14-16 MARSHALL AVE

LANDSCAPE REPORT
S4.55 - REV C
PR148589-1

Prepared for:
DASCO

UPDATES TO REPORT - S4.55 [A]:

3.8 LEVEL 15 PLAN

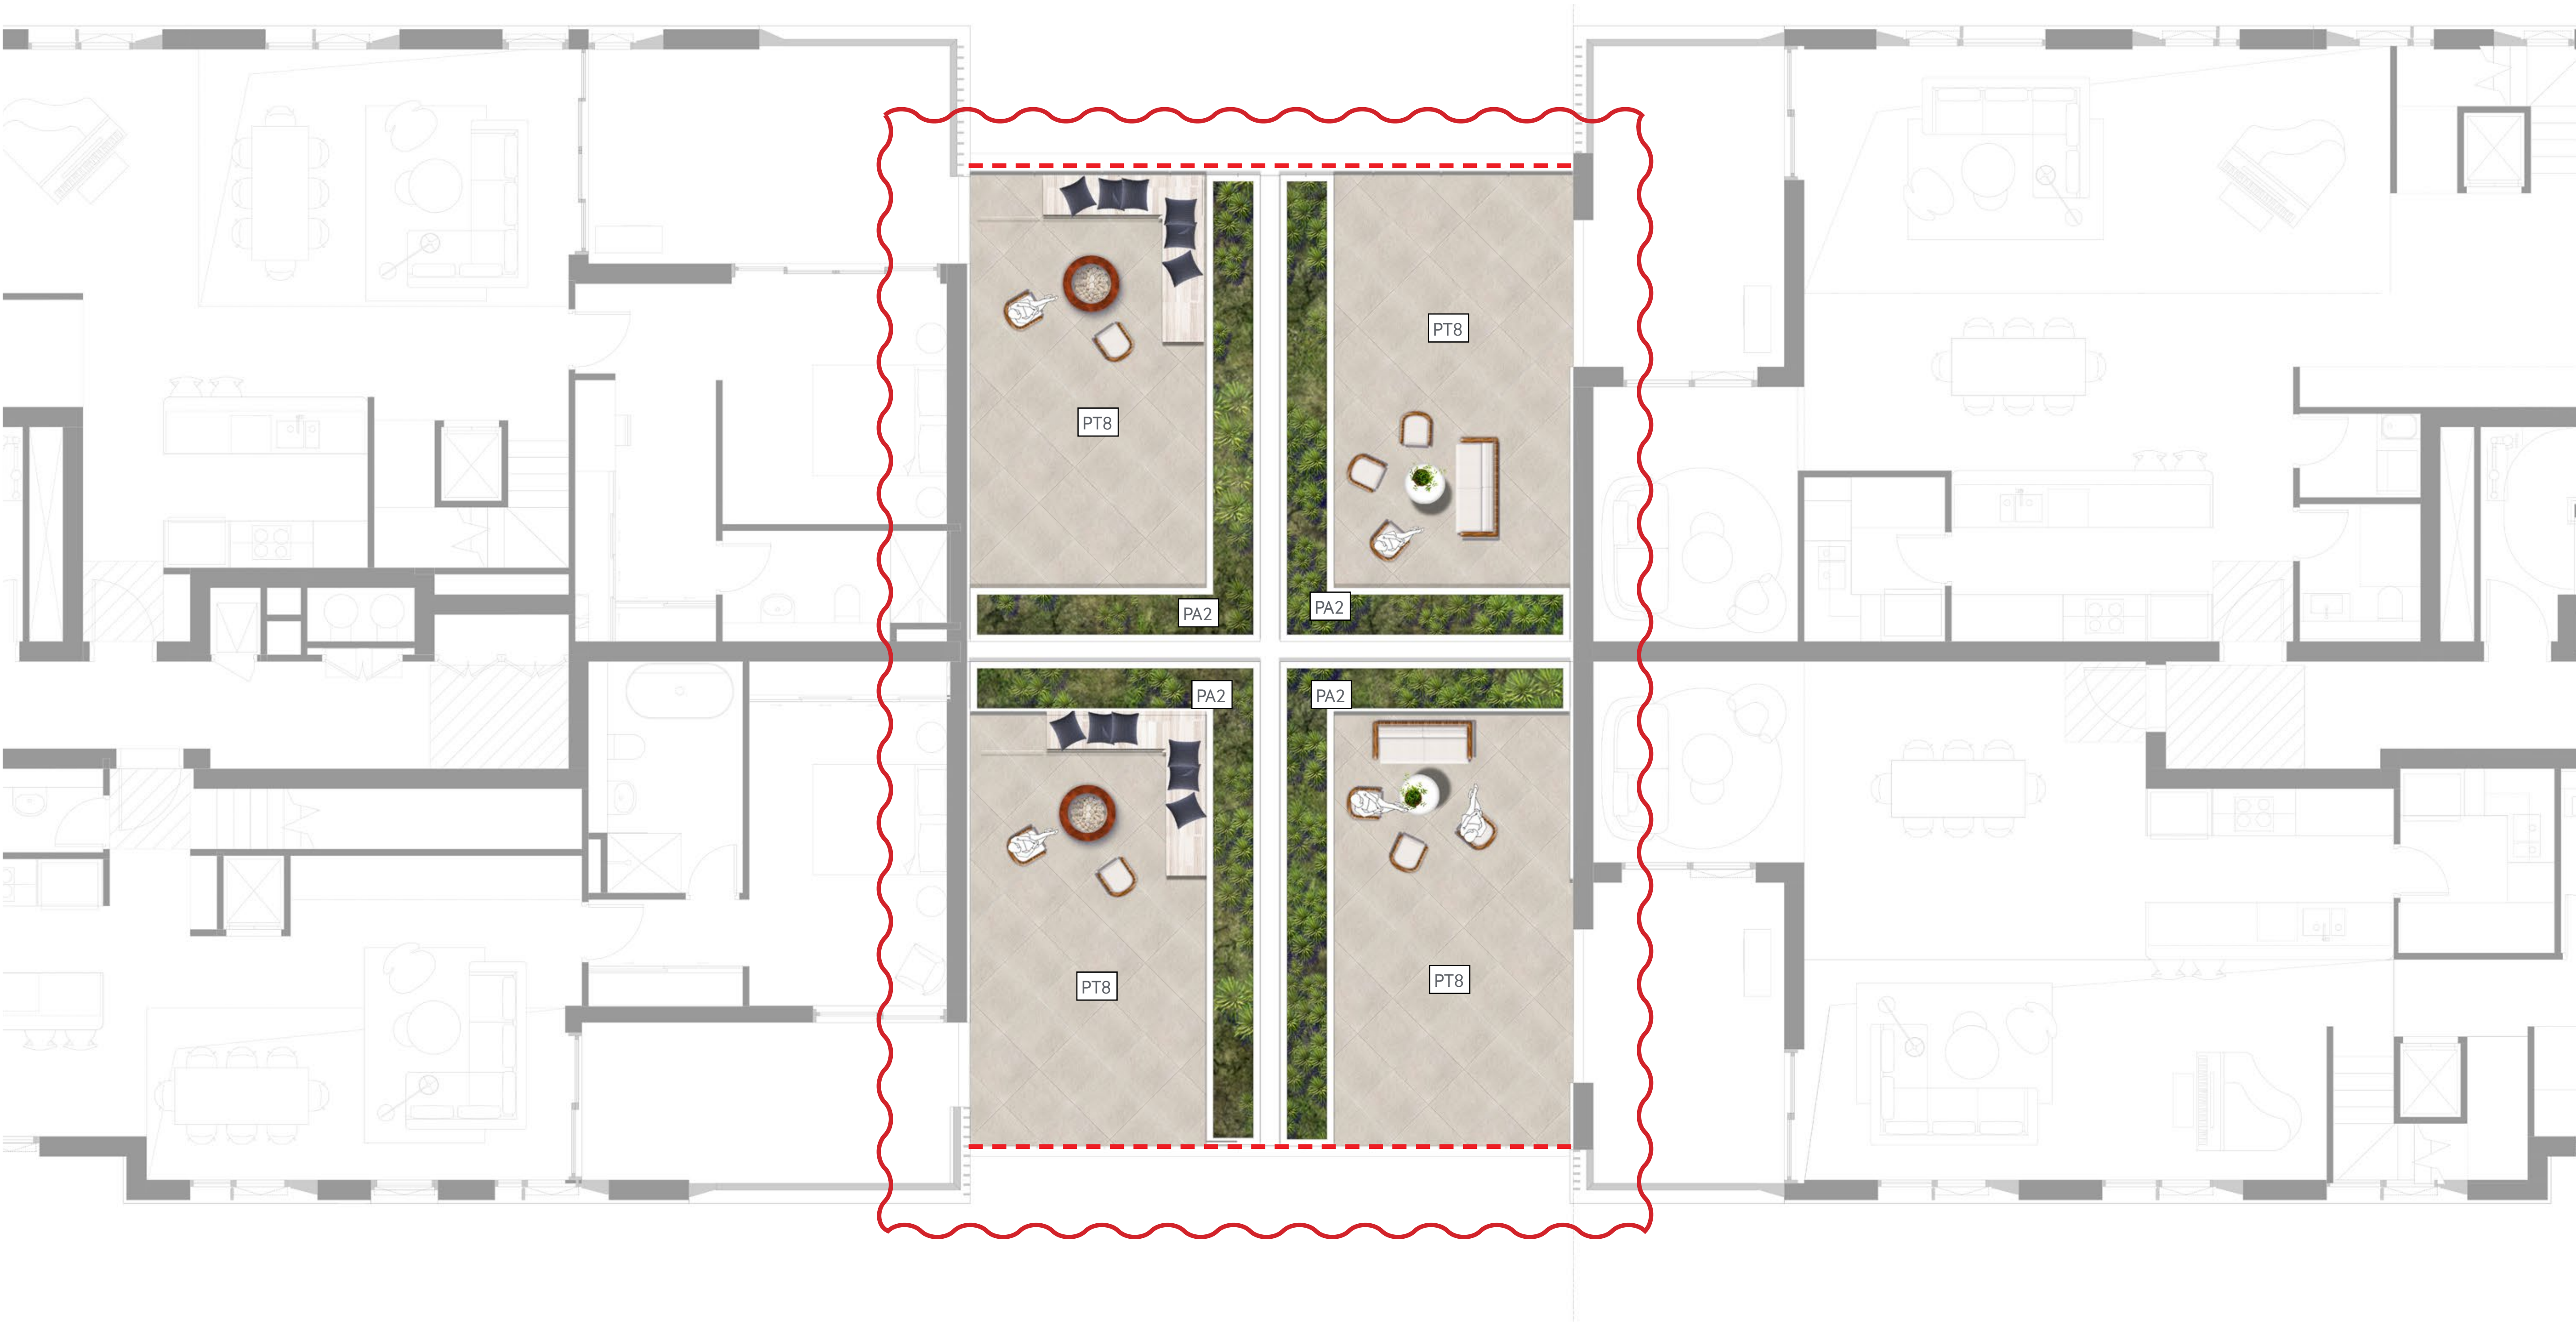
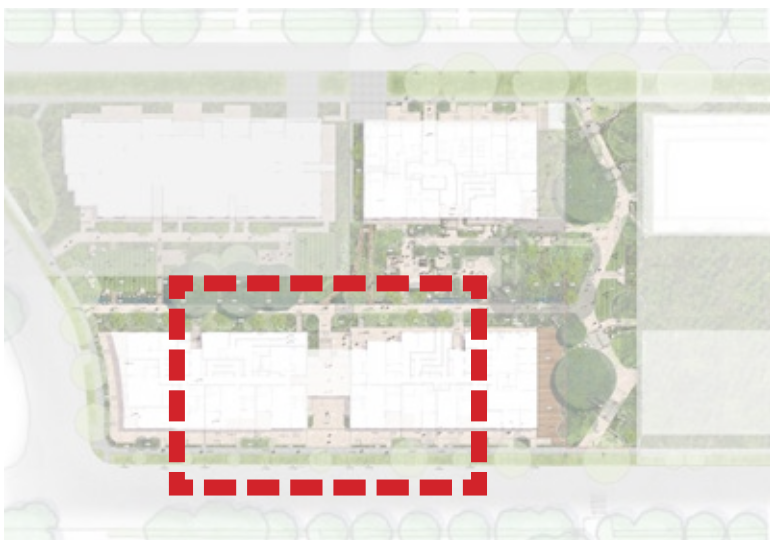
- 3.8 LEVEL 13 PLAN UPDATED TO LEVEL 15
CHANGE TO LEVEL 15 COS DESIGN TO SIMPLIFIED POS DESIGN
- 4.1.2 LEVEL 15 SOIL PLAN UPDATE TO MATCH 3.8 CHANGES
- 4.5 LEVEL 15 PLANTING PLAN UPDATE TO MATCH 3.8 CHANGES

3.9 ROOF TERRACE PLAN

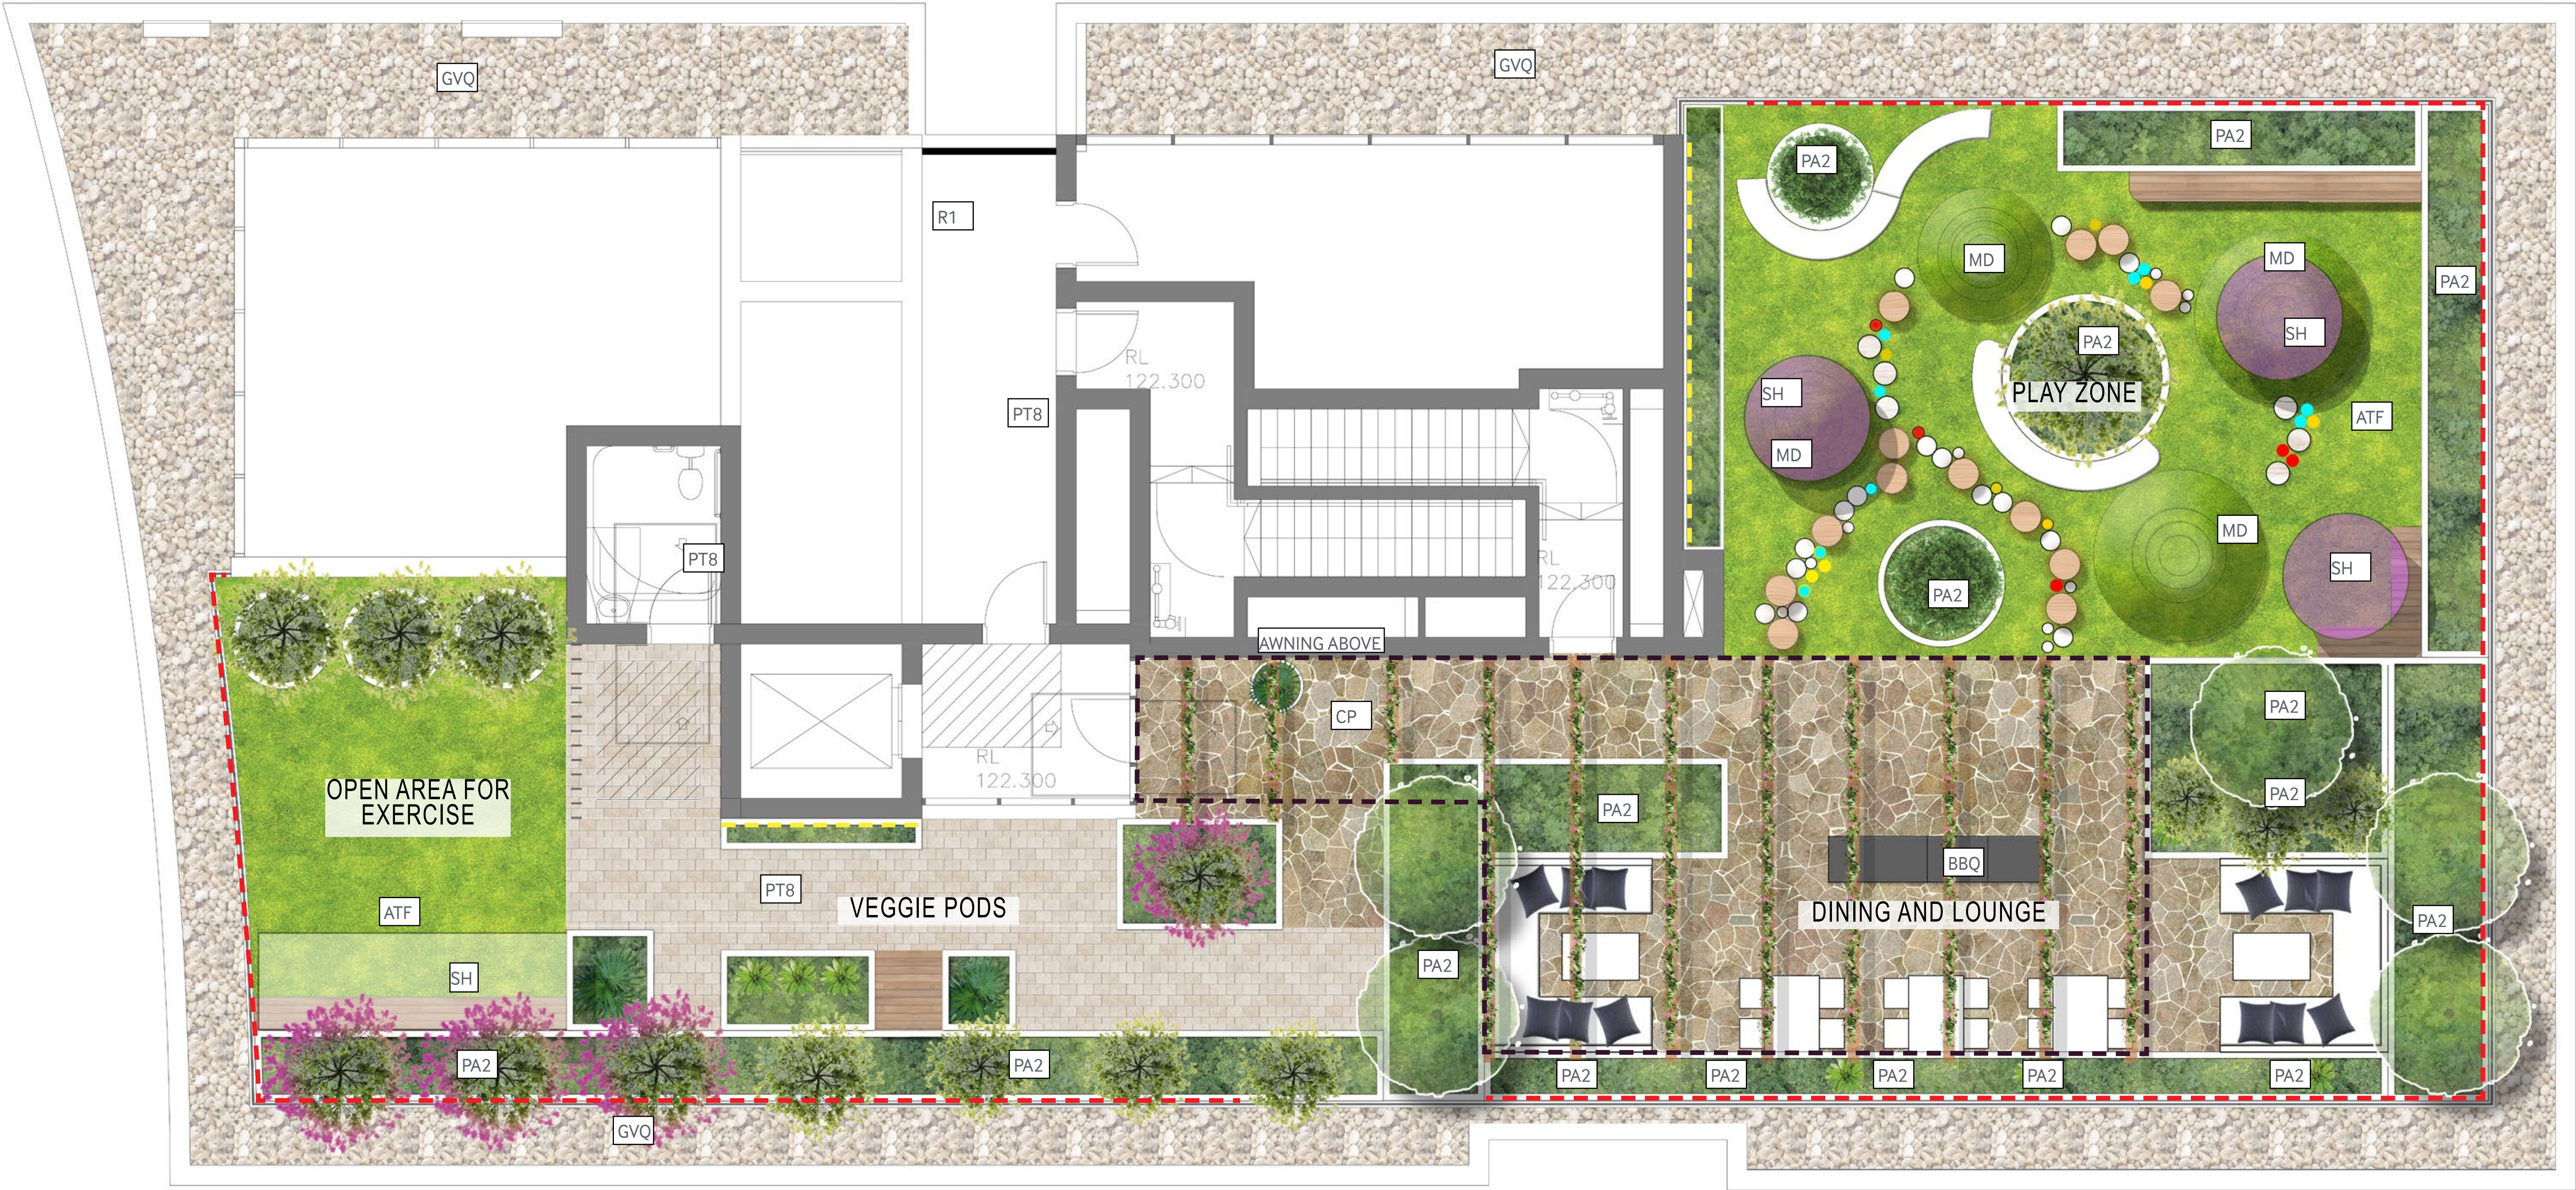
- 3.2 - 3.3.3 - INDIVIDUAL REVISION CLOUDS ADDED AS PER COUNCIL REQUEST
- 3.8 - LEVEL 13 PLAN AMENDED, PLANTER AREA INCREASED IN RESPONSE TO COUNCIL COMMENT
- 3.9 - ROOF TERRACE PLAN AMENDED, PLANTER AREA INCREASED IN RESPONSE TO COUNCIL COMMENT
- 4.1 - DEEP SOIL PLAN - INDIVIDUAL REVISION CLOUDS ADDED
- 4.2 - SOIL DEPTH PLAN AMENDED - SOIL VOLUME INCREASED IN RESPONSE TO COUNCIL COMMENT
- 4.4 - CANOPY PLAN AMENDED (SOME TREES ON LEVEL 13 SUBSTITUTED FOR SHRUBS)
- 4.5 - TREE PLAN AMENED (FIG SPECIES SUBSTITUTED AS PER COUNCIL COMMENT, SOME TREES SUBSTITUTED FOR SHRUBS)
- 4.7 - LEVEL 13 PLANTING PLAN AMENDED - FIG SUBSTITUTED FOR FRANGIPANI, SOME TREES SUBSTITUED FOR SHRUBS, MORE PLANTS ADDED TO CENTRAL PLANTER
- 4.8 - ROOF PLANTING AMENDED - FIG SUBSTITUTED FOR FRANGIPANI, SOME TREES SUBSTITUED FOR SHRUBS, MORE PLANTS ADDED TO LARGER POT
- 4.9 - PLANTING SCHEDULE AMENDED
